Wendy's Restaurant

MEMORANDUM

To: Building Inspector
From: Planning Department
Date: May 20, 2022
Subject: Building Permit Application for Wendy's Restaurant
3399 Crompond Road, *aka* Staples Plaza
SBL: 36.06-2-76

SHEET NAME:
**EXTERIOR
ELEVATIONS**

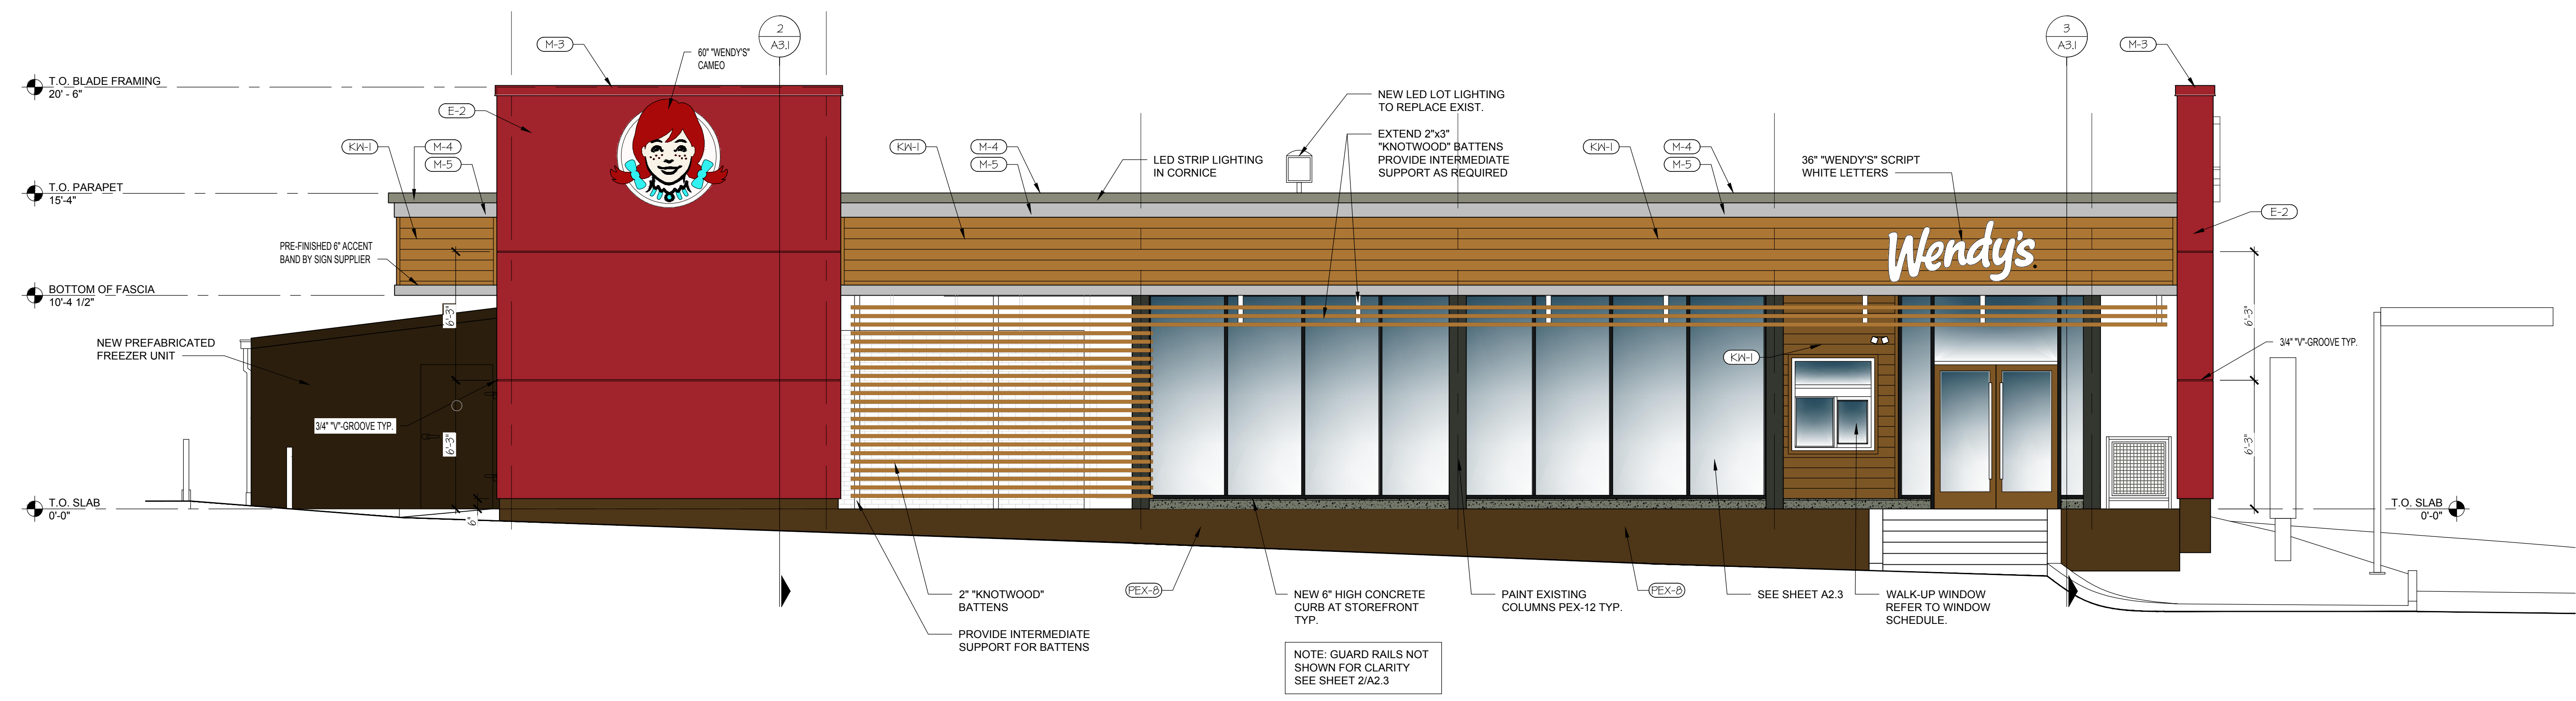
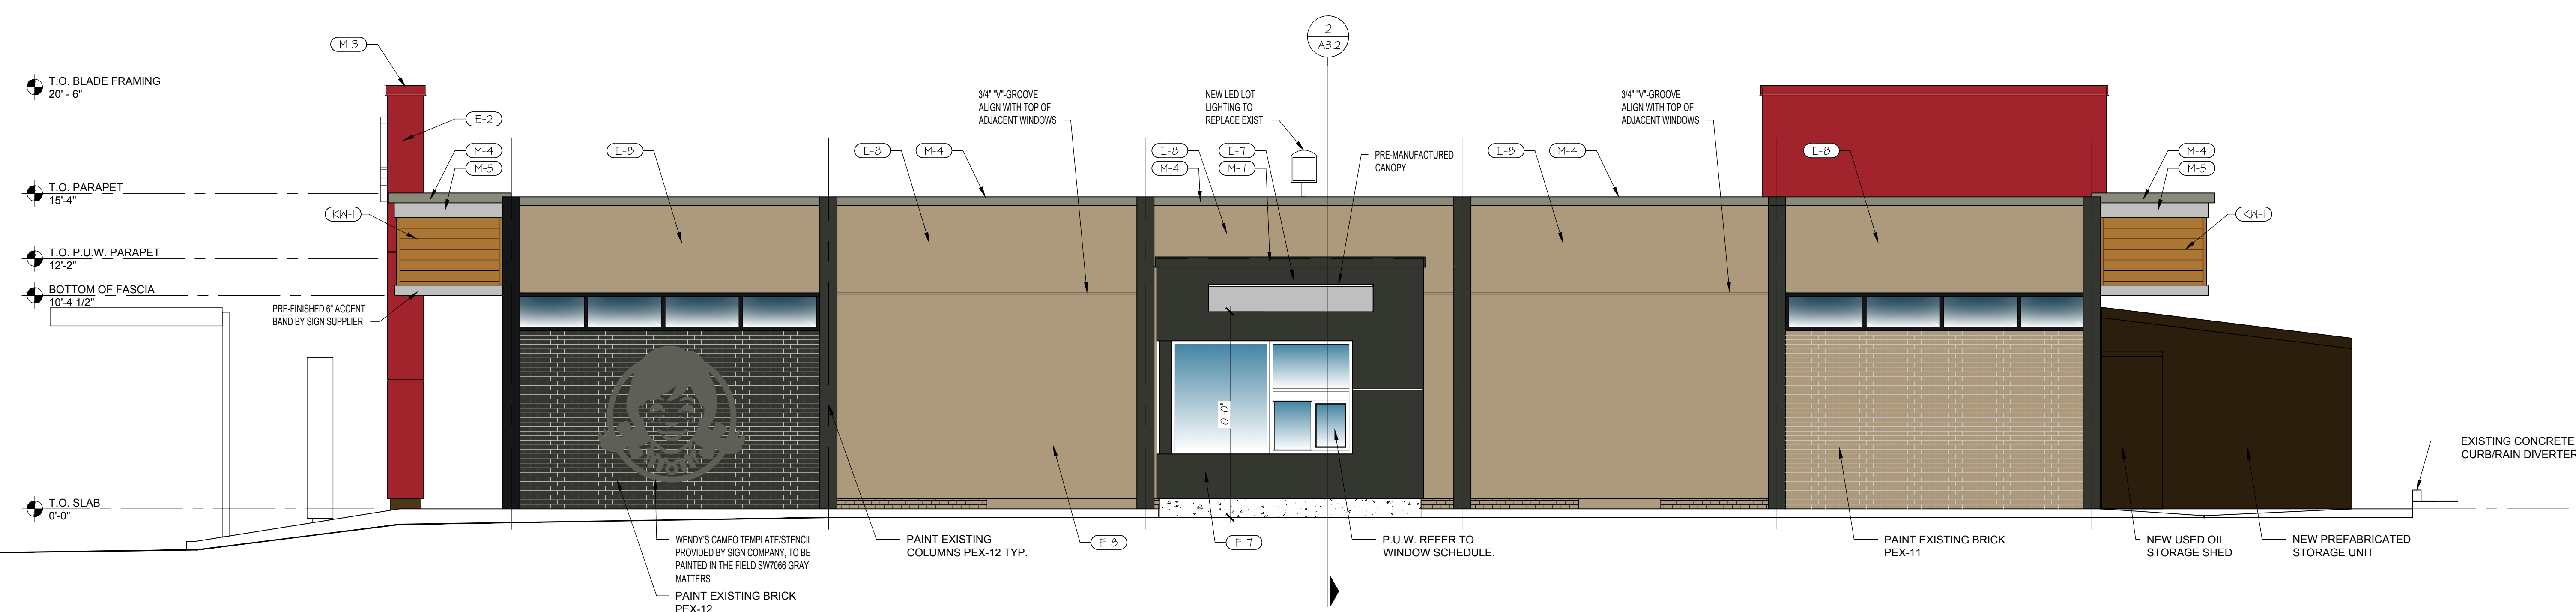
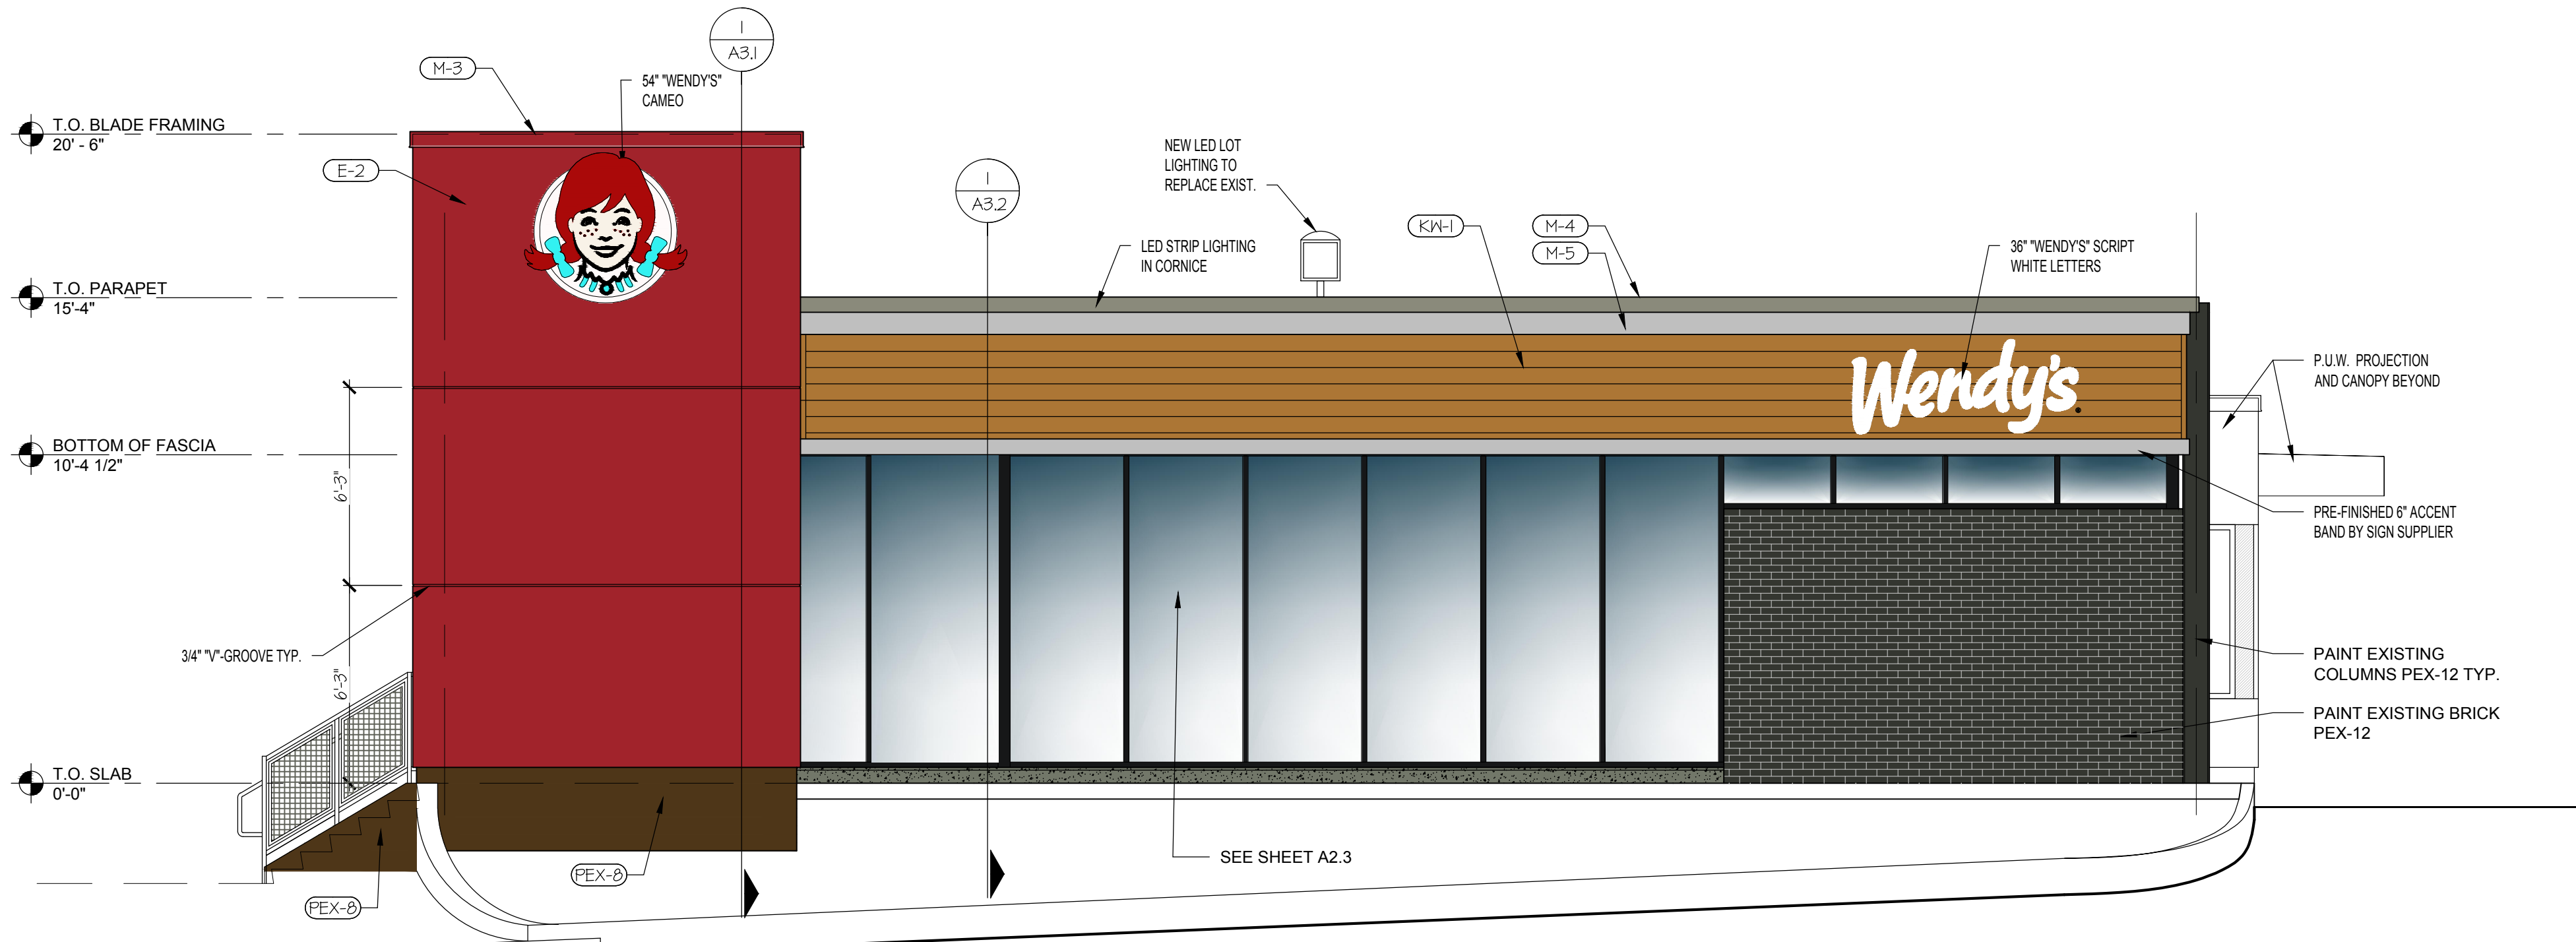
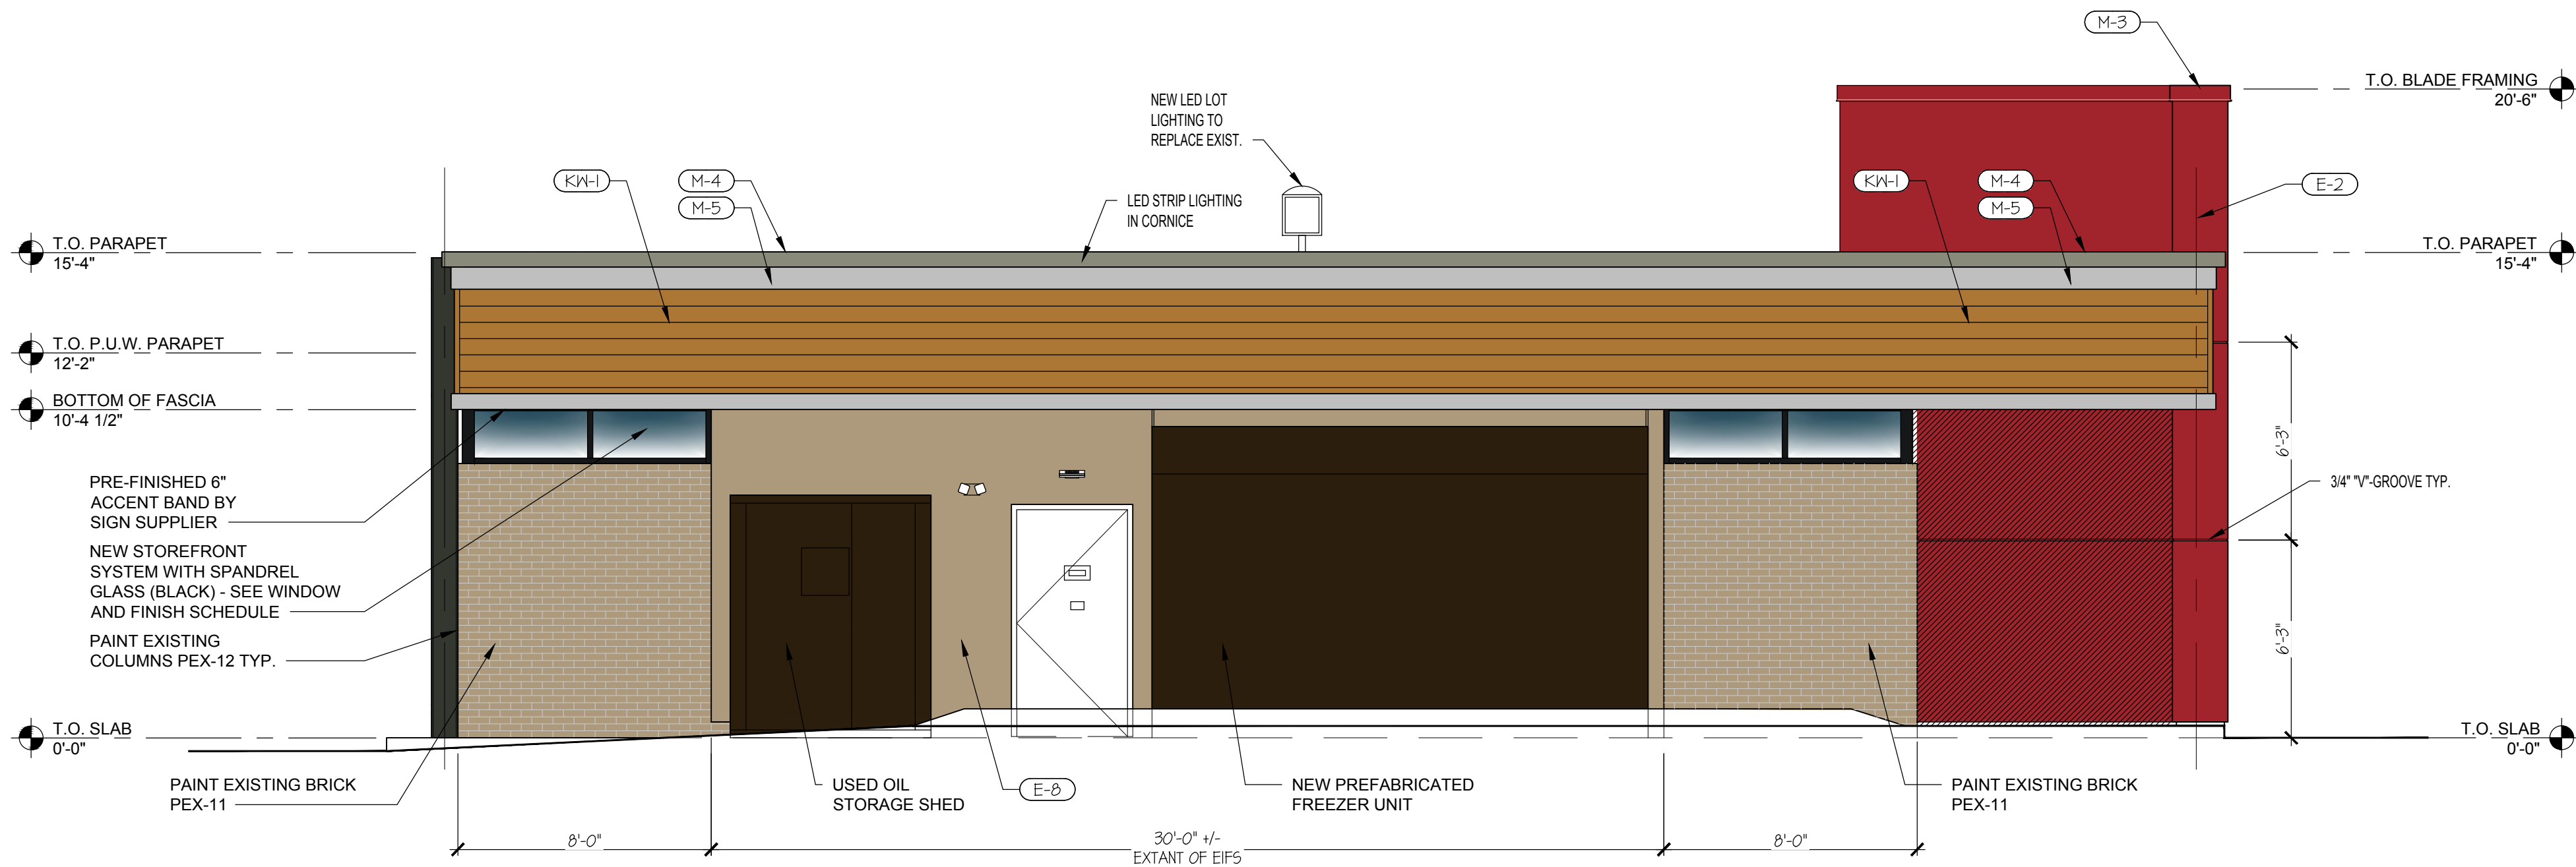
The project proposes to demolish all aluminum storefront and glazing, clerestory windows, and a storage enclosure at the rear of the building. Existing brick veneer is proposed to be painted in varying colors and two acrylic stucco accent walls nearly 21 feet high are to be added at building perimeter. The storage

enclosure will be replaced with a walk-in refrigeration unit of unknown finish or color. The fascia and parapet will be clad in horizontal simulated wood material. Additional wood screen panels are proposed at the perimeter. In other words, a wholesale architectural redesign is proposed. **While any commercial renovation requires ABACA review, it is particularly the case with such an overall set of external modifications.**

The project proposes an entirely new sign scheme and proposes two 21' high walls on which signage is proposed to be affixed. A third logo sign is proposed to be placed at eye level on a section of existing brick wall. As you may recall, the Town code provides that master sign plans be developed for commercial complexes and this site has such a master sign plan. If the proposed signs comply with the master sign plan, a permit may be issued without further review. We are unaware as to whether such a compliance check was conducted, but given the new accent walls at 21' high with signage reaching over 18' high, we believe it is not compliant with the master sign plan and therefore, on that basis alone, **triggers master sign plan review by the Planning Board and potential referral to the ABACA.** No determination has been made relative to their size in this writing, nor should any conclusion be assumed.
